CONSULTEE RESPONSE (Council's Arboriculturist)

Reference: FG/17/26/T

Location: Oaklawn, Greystoke Road, Ferring, BN12 5JL

Proposal: Fell 1no. *illex* oak (T1) and crown reduction on 1no. *illex* oak (T2) to leave a height and spread of 6m.

Figure 2 Positions of final cuts

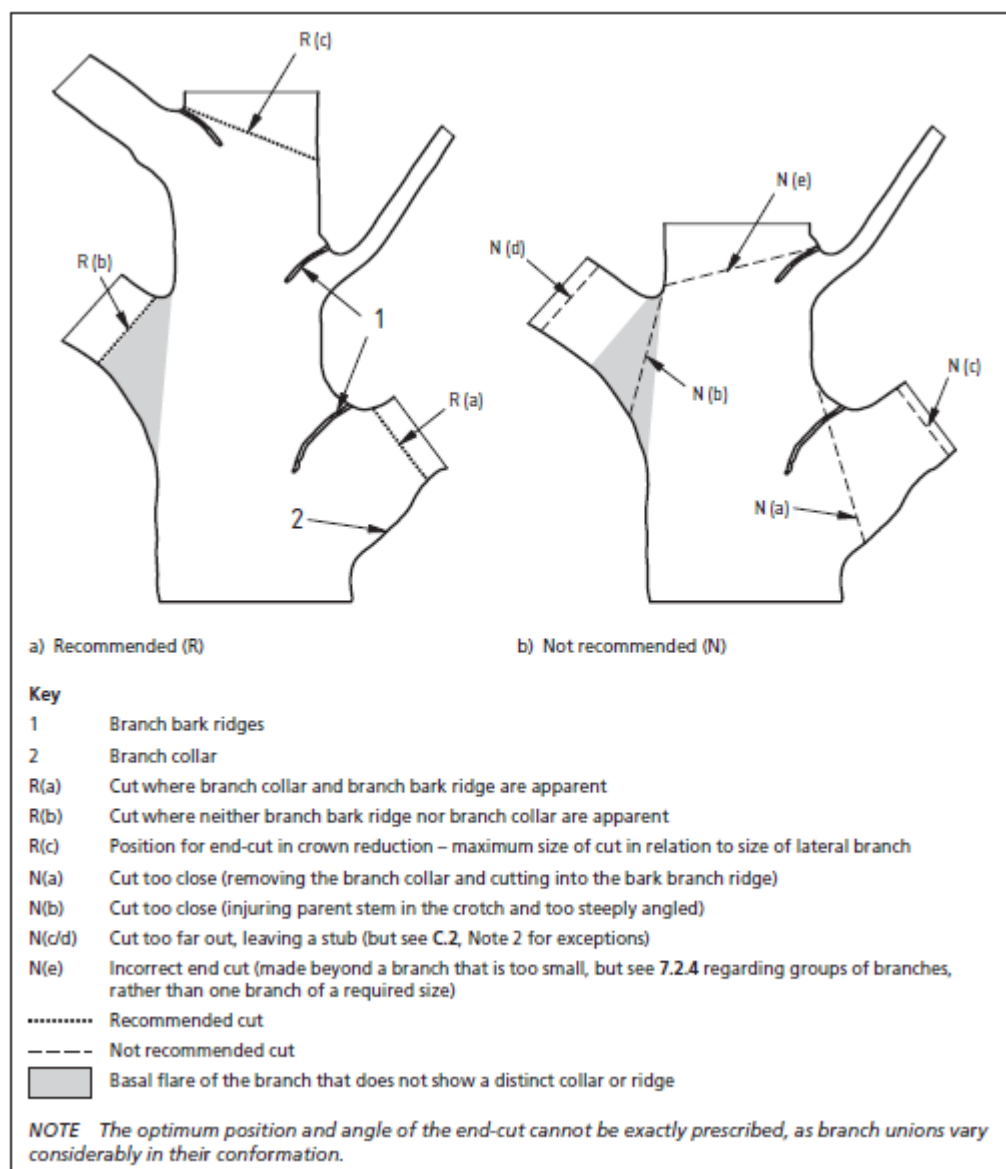
Part a) Where whole branches are to be removed and final cuts made close to the trunk or branch union they are to be made as shown in Figure 2 of BS3998:2010
